Comments of Public Service Company of New Hampshire

EPA's Revised Draft National Pollutant Discharge Elimination System

Permit No. NH 0001465

Merrimack Station

Figure 4-4
 Monfalcone Power Station - FGD Treatment System Flow Schematic

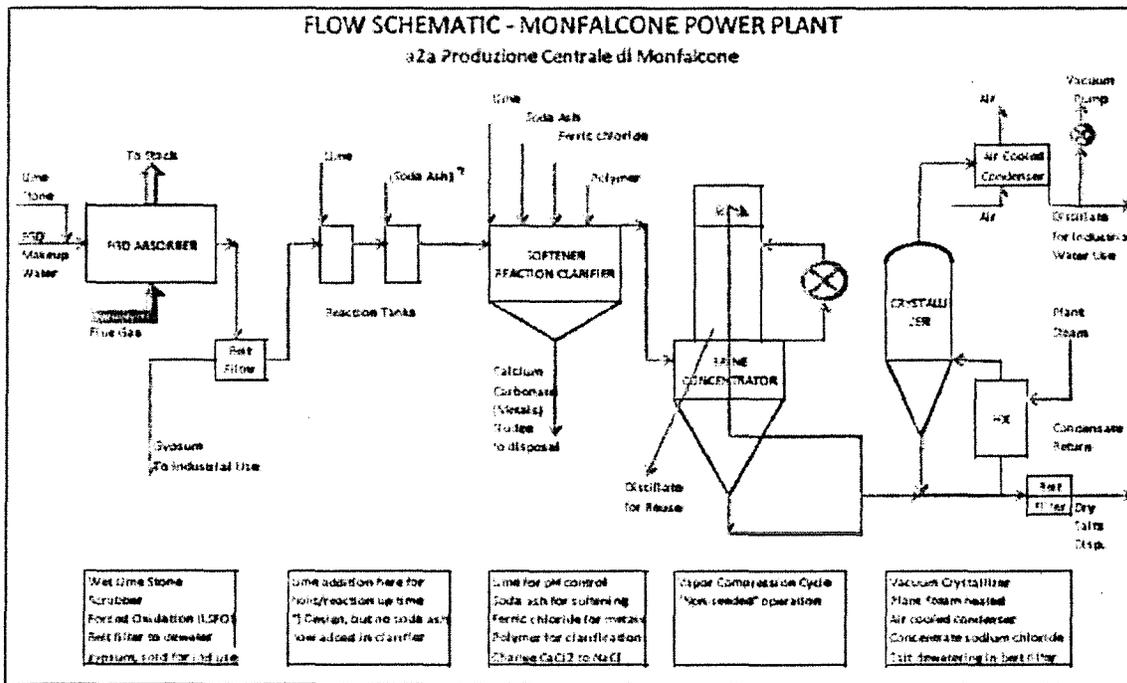
A block flow diagram for the system (from the facility's permit), plainly shows a discharge from the system (labeled "Distillate for Industrial Water Use").

Thus, the system does not achieve complete ZLD.
